Project	IEEE 802.16 Broadband Wireless Access Working Group http://ieee802.org/16 >
Title	Ambiguity in PHY layer §8.3 OFDM frequency and timing requirements
Date Submitted	2005-03-11
Source(s)	Juergen Otterbach Joerg Schaepperle Roland Muenzner Torsten Fahldieck Alcatel SEL AG Voice: +49-711-821-32255 Fax: +49-711-821-32453 Juergen.Otterbach@alcatel.de
Re:	Response to call for comments IEEE P802.16-2004/Cor1-D1
Abstract	Correction of inconsistencies for 802.16-2004 PHY §8.3 OFDM
Purpose	Resolving ambiguity in PHY layer §8.3 OFDM
Notice	This document has been prepared to assist IEEE 802.16. It is offered as a basis for discussion and is not binding on the contributing individual(s) or organization(s). The material in this document is subject to change in form and content after further study. The contributor(s) reserve(s) the right to add, amend or withdraw material contained herein.
Release	The contributor grants a free, irrevocable license to the IEEE to incorporate material contained in this contribution, and any modifications thereof, in the creation of an IEEE Standards publication; to copyright in the IEEE's name any IEEE Standards publication even though it may include portion

Figure 1: Possible differences in OFDM symbol duration

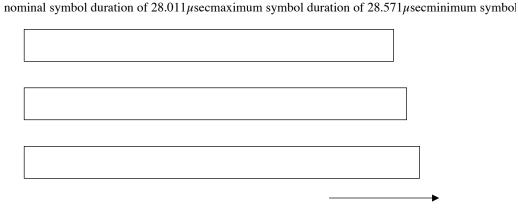
According to this tolerance the SS is allowed to transmit OFDM symbols with differences in duration as shown in Figure 1 with a Cyclic Prefix (CP) time of 1/4 of the "useful" symbol time assumed. The symbol time extension by the CP is 256/4 = 64 samples. The whole symbol is equivalent to 320 samples that correspond to symbol time $T_s = 28.011\mu$ sec nominal.

In a view of the Base Station receiver a nominal symbol duration of 28.011 μ sec is expected. An UL OFDM symbol with maximum symbol duration of 28.571 μ sec is 6.4 samples longer than the expected nominal symbol duration of 28.011 μ sec. A detection of the short preamble using time domain correlator principles would fail.

At the SS, both the transmitted center frequency and the symbol clock frequency shall be synchronized and locked to the BS with a tolerance of maximum 2% of the subcarrier spacing. Additionally the symbol clock frequency at the SS shall be locked to the center frequency at the SS which guarantees a relative tolerance for the symbol clock frequency at the SS of maximum 0.02*(subcarrier spacing)/(center frequency).
